DREAMPORT VILLAGES

City Council –Special Meeting
August 9, 2017

**Regional Gateway
Commerce
Center PAD**

**Casa Grande
Mountain Ranch
PAD**

TRAILHEADS

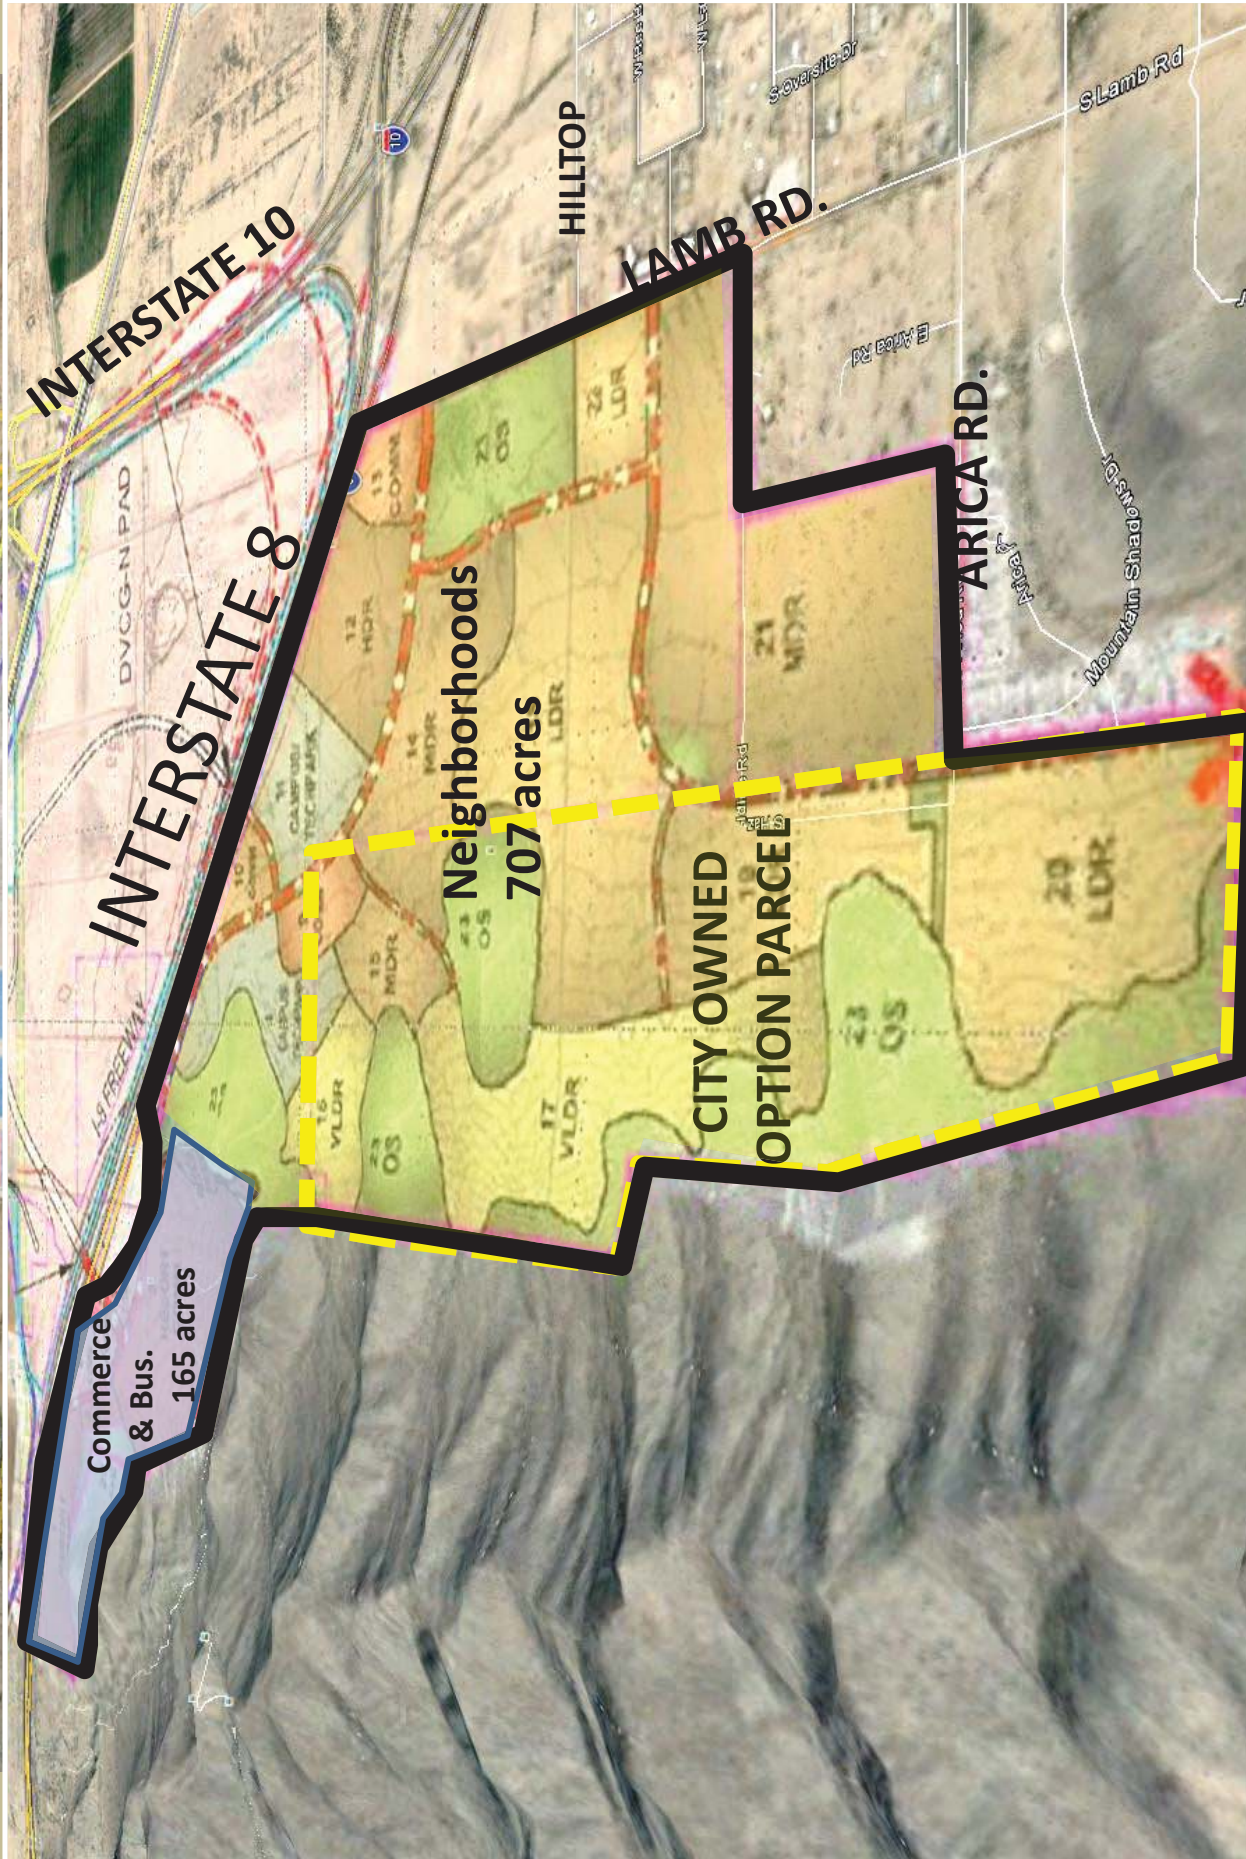
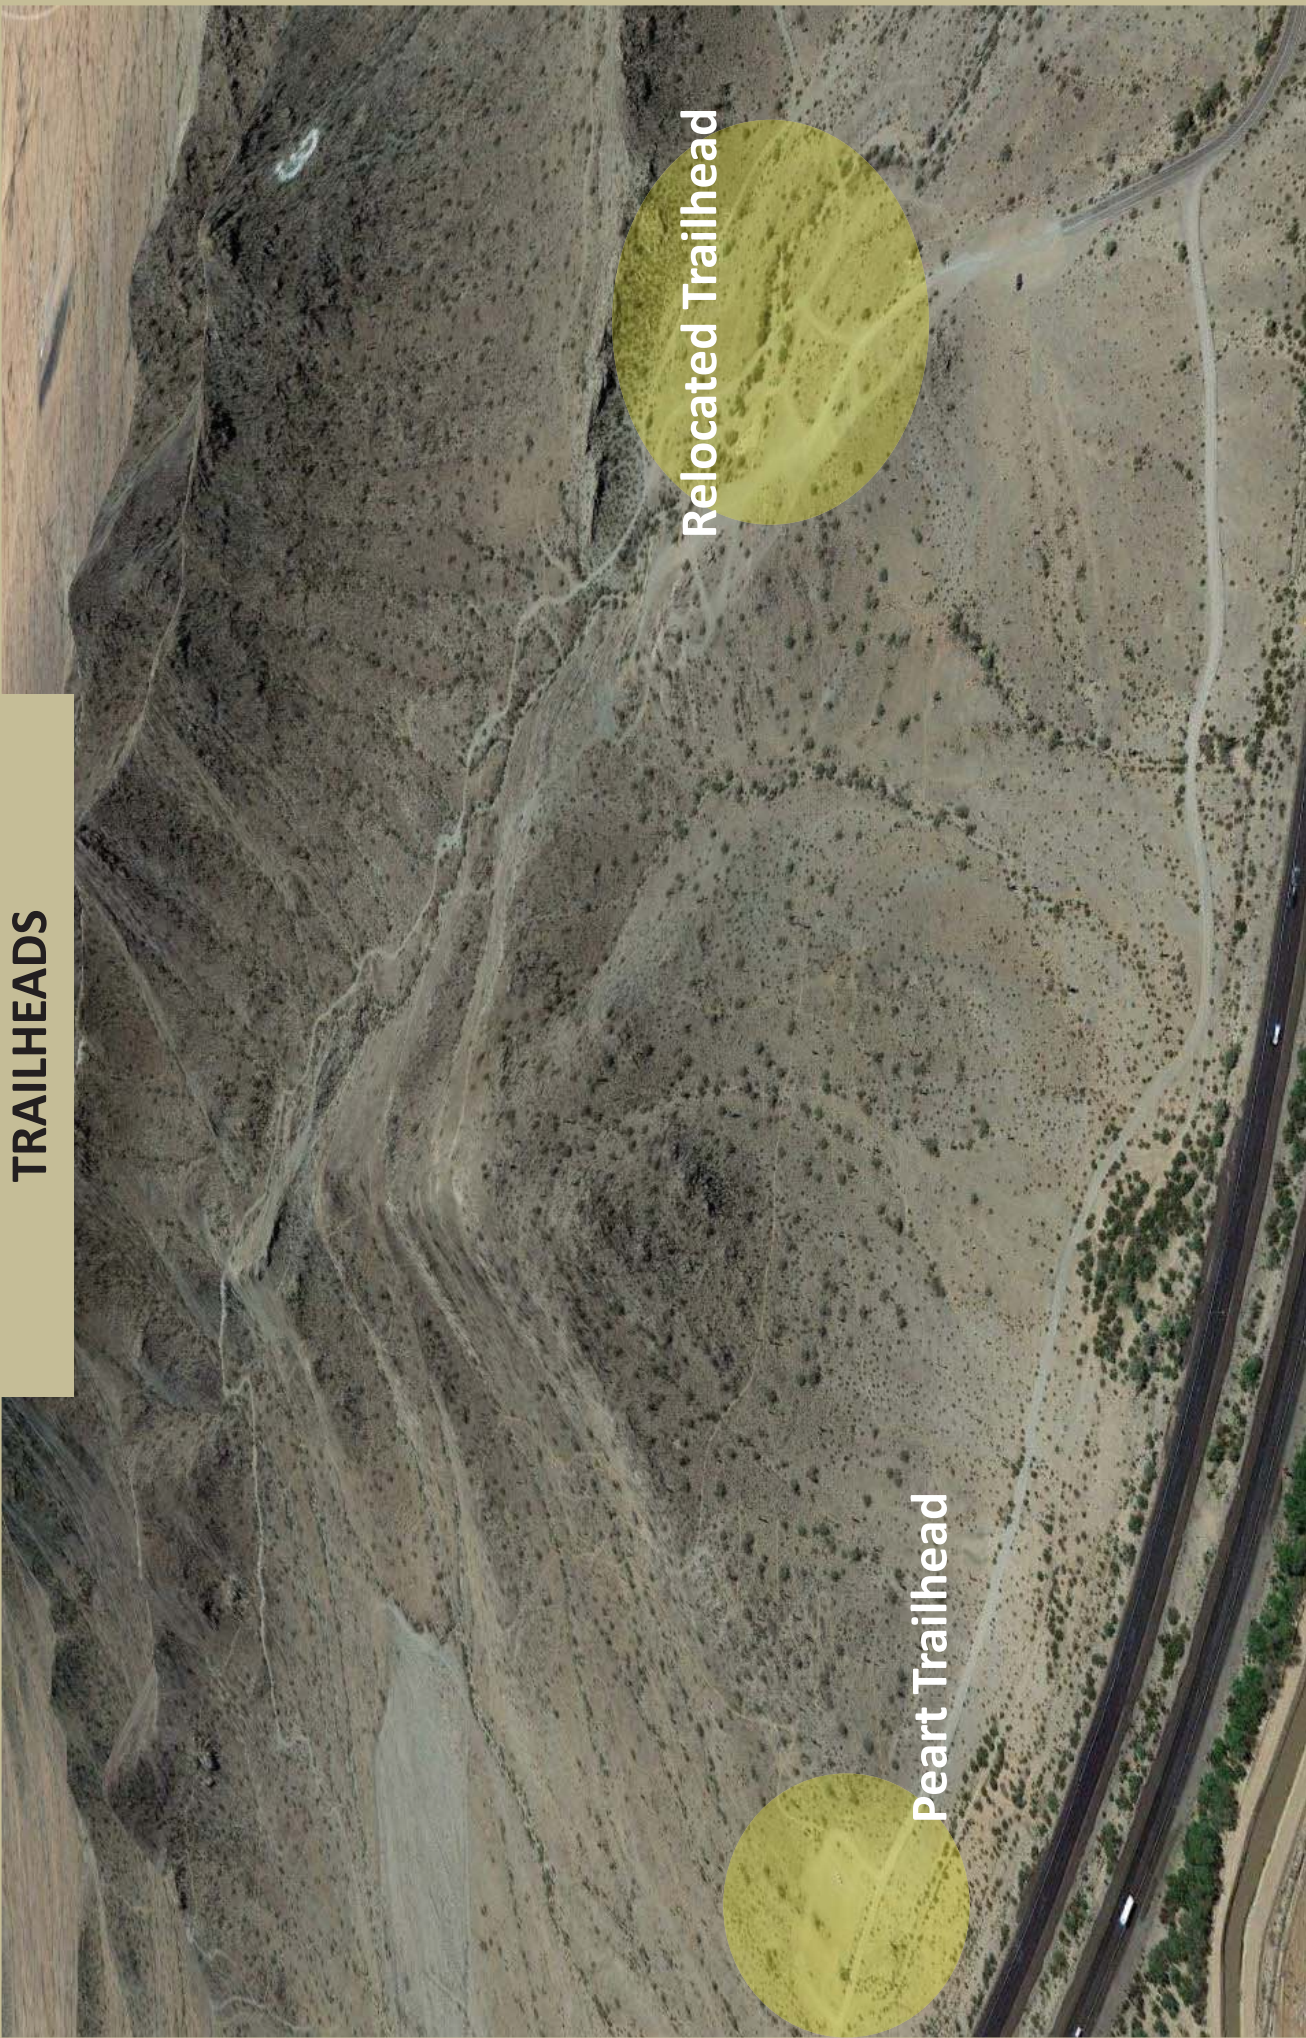
Existing Peart Rd. Trailhead-to be removed

Land for new Trailhead/ Parking (City of CG)

1. Land must be dedicated to the City at the west boundary of the PAD for a roadway and trail access prior to the abandonment of the existing Peart trailhead.

TRAILHEADS

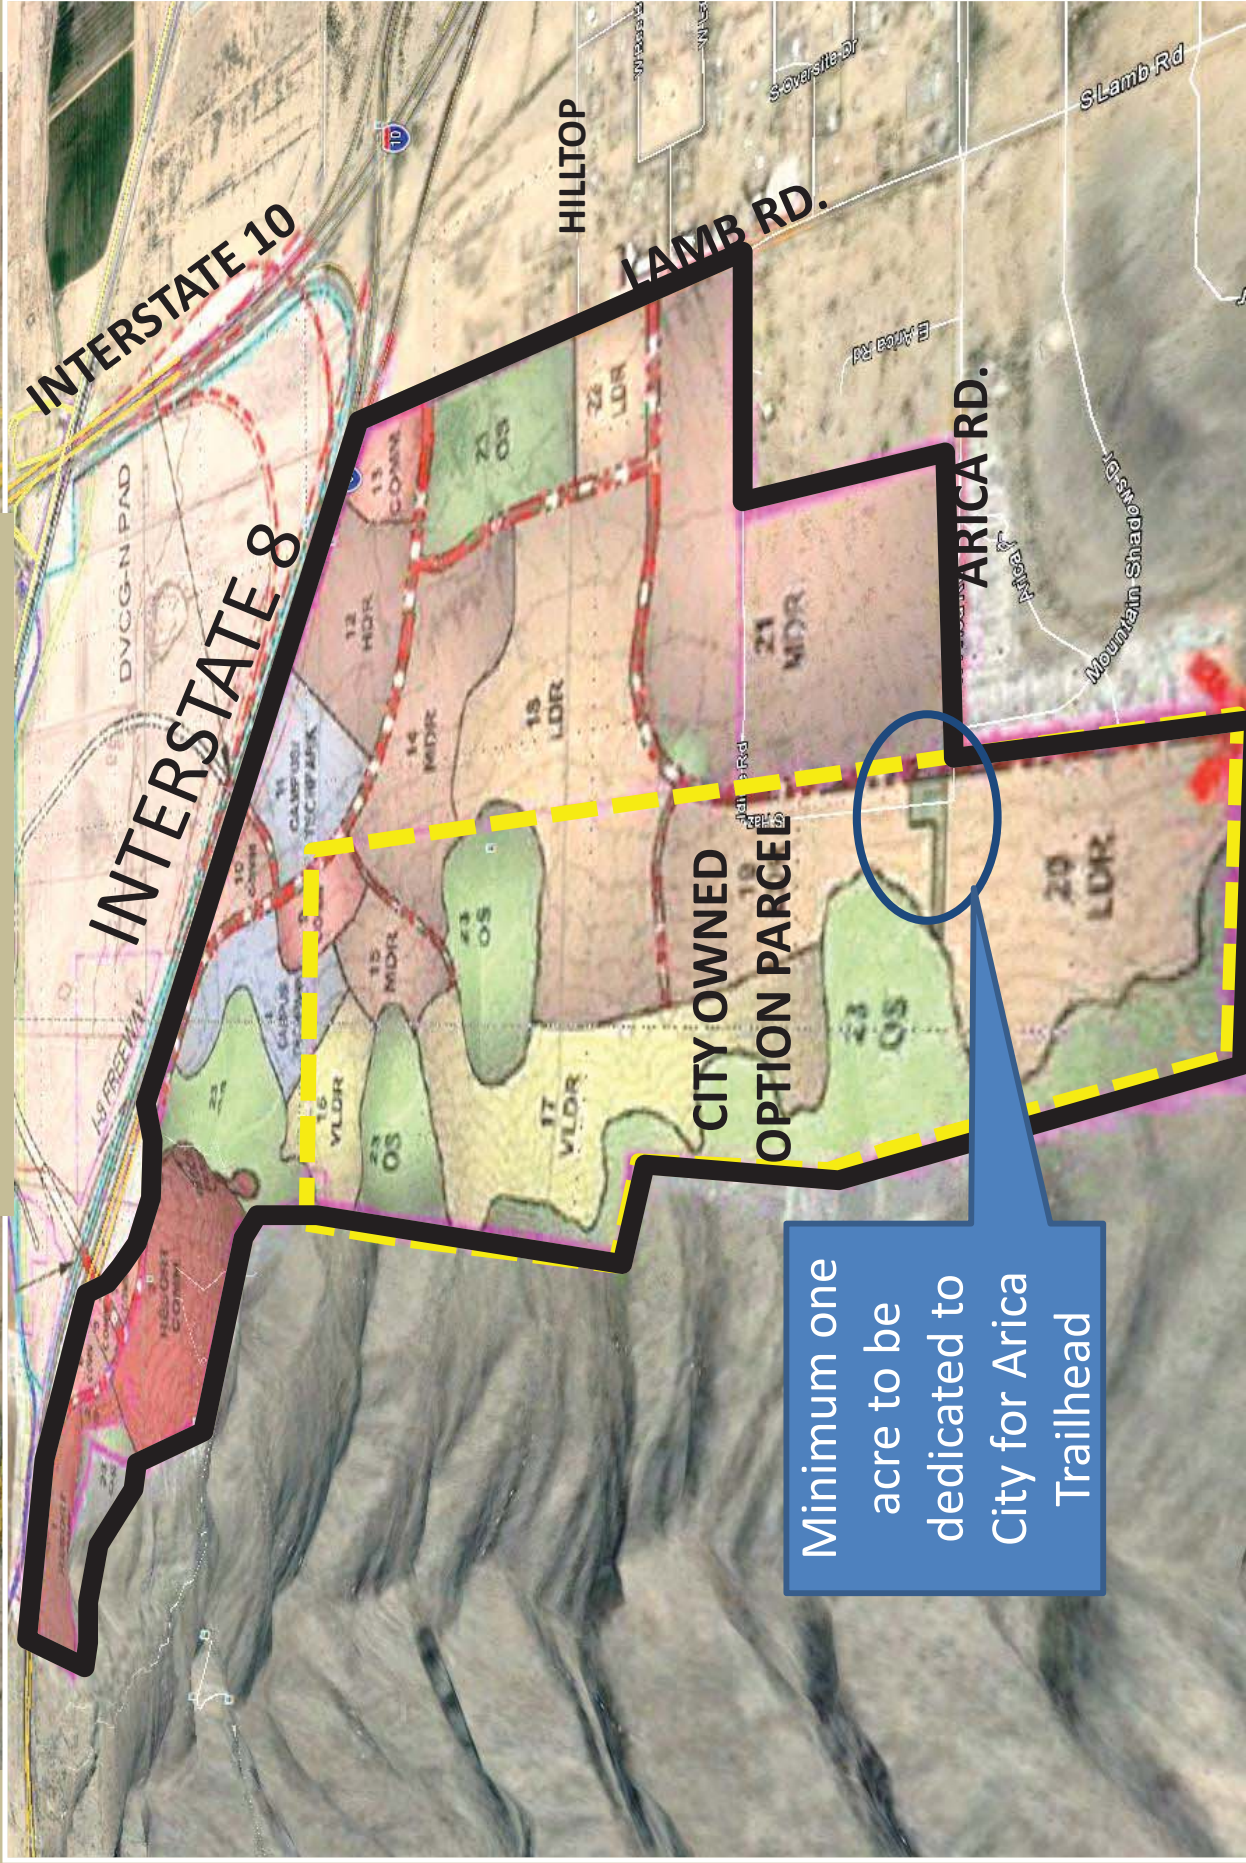
Minimum one acre to be dedicated to City for Arica Trailhead

2. A minimum of one acre of land must be dedicated to the City for the existing Arica Road trailhead and parking area prior to the approval of any Major Site Plans or Preliminary Plat within the PAD.
